Article: ASA-17-01C

### 2016 - 2017 Sportsman 450HO / 570 1-UP Optional RH Side Panel Close Off Kit

# 2016–2017 SPORTSMAN 450/570 1-UP HEAT MANAGEMENT KIT

**P/N 2207445**

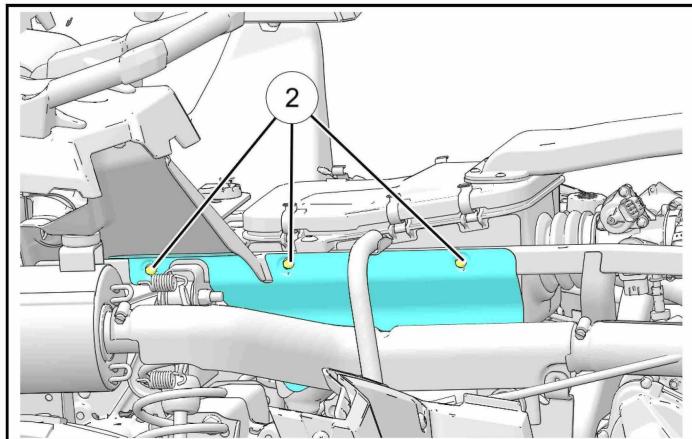
5. If an existing air box shield is present, remove the three 3/8 inch (10 mm) fasteners ② and remove the shield. Discard the old shield.

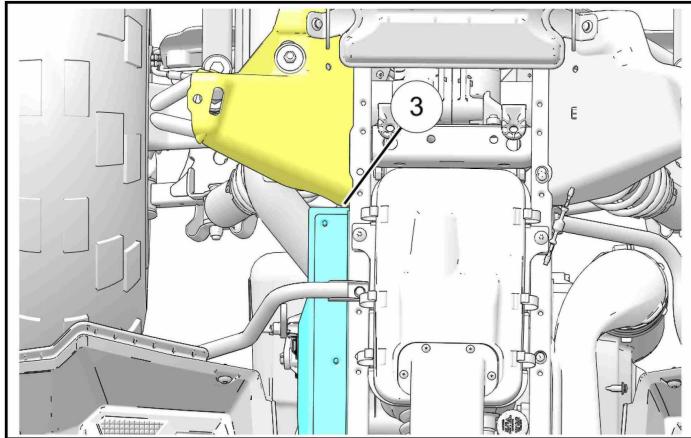
7. Guide the new heat shield (P/N 2636957) over the exhaust pipe and line up with the edge of the shock tower ③ as shown.

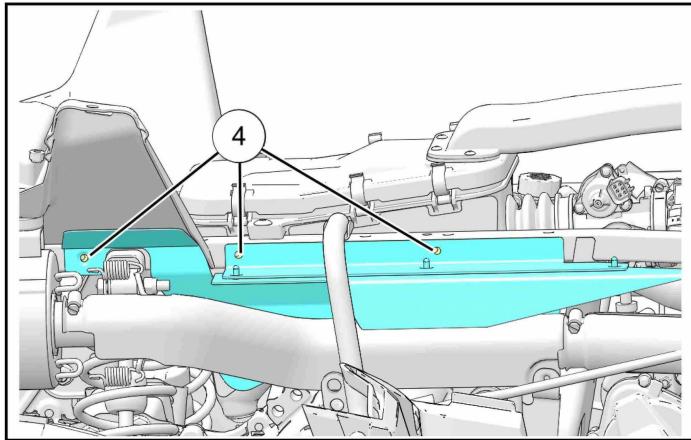
8. Mark the location of the mounting holes ④ in the heat shield with a center punch. Remove the shield and drill the marked mounting holes with a 3/16 inch drill bit.

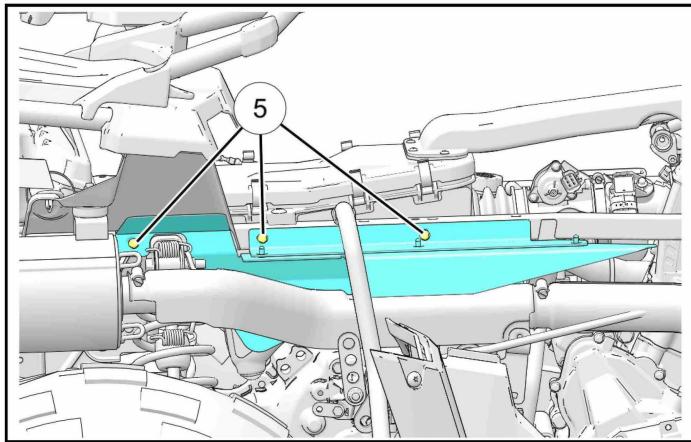
10. Install the three self tapping 3/8 inch (10 mm) heat shield retaining bolts ⑤ (P/N 7517386) into the mounting holes on the frame. Torque until fully seated.

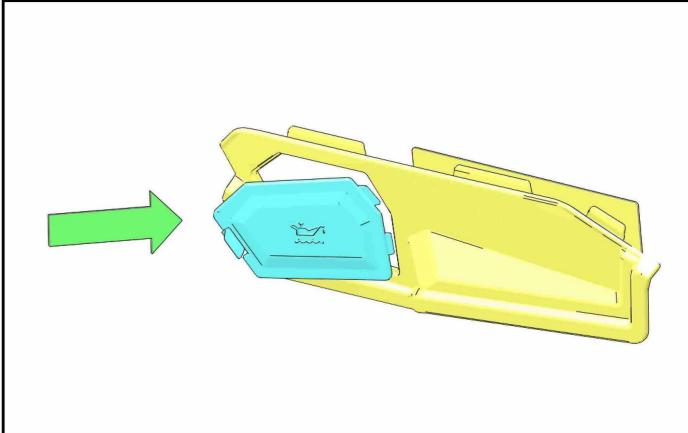
1. Install the access panel (P/N 2630741-070) into the close off panel (P/N 2636956-070) by inserting the tabs into the close off panel as shown.

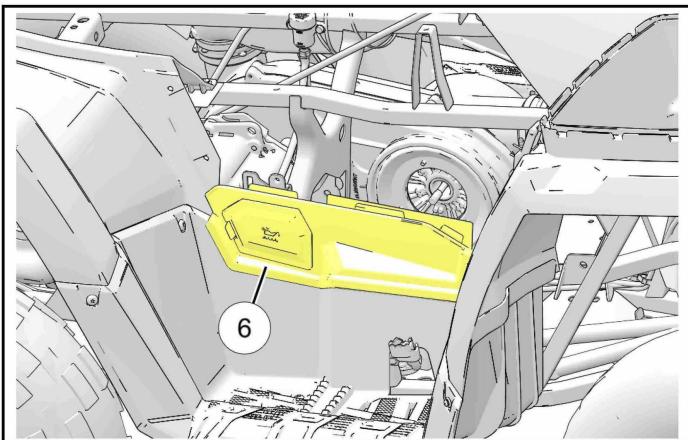
2. Install the new assembled close off panel ⑥ into the right hand foot well as shown.
